SERVICE BULLETIN

No. SB-AG-53

Revision NC; 7/14/2010

S2R-T660 RUDDER **INSPECTION**

Figure 53-1: Comparison of Good & Bad Rudder

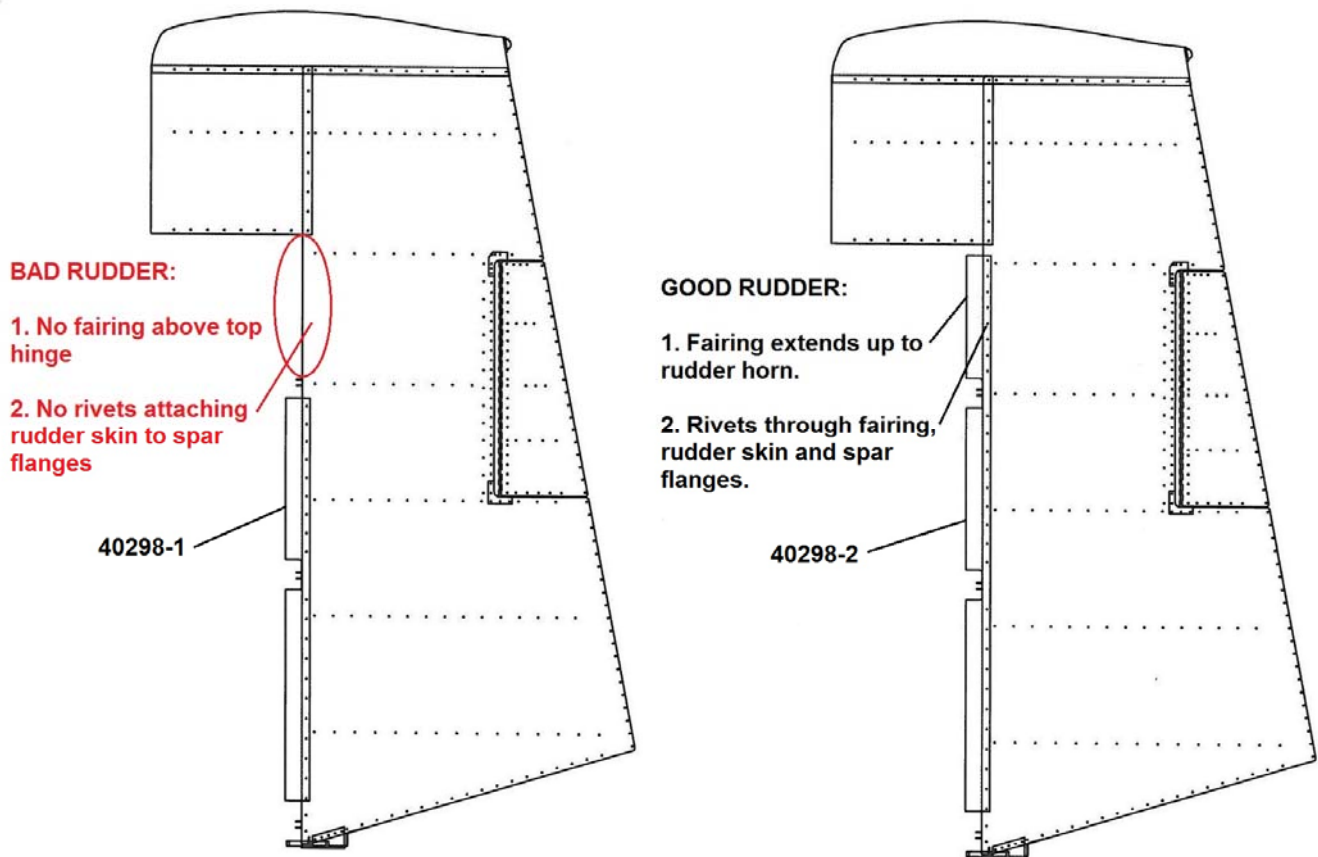
The cause of this failure was a manufacturing error in that the wrong fairing was installed on the front of the rudder spar (see Figure 53-1). The correct fairing extends all the way up to the rudder horn, whereas the one installed stopped at the top hinge. This error was compounded by the fact that no rivets were installed to attach the rudder skin to the rudder spar flanges between the top hinge and the rudder horn. This portion of the rudder spar was therefore much weaker than it should have been, and was inadequate in the long run to sustain the twisting force applied to it by the rudder horn every time the rudder was deflected significantly.

Prior to further flight the rudder must be inspected at the spar between the upper hinge and the aerodynamic balance (horn) to ensure that it has the 40298-2 fairing and that it is properly installed (see Figure 53-1).

1. If the rudder does not have the 40298-2 fairing installed properly, replace the rudder assembly with a new 95265-15 or 17 rudder, as applicable. It is not sufficient to just install the proper fairing, since the rudder structure may have already sustained significant damage.
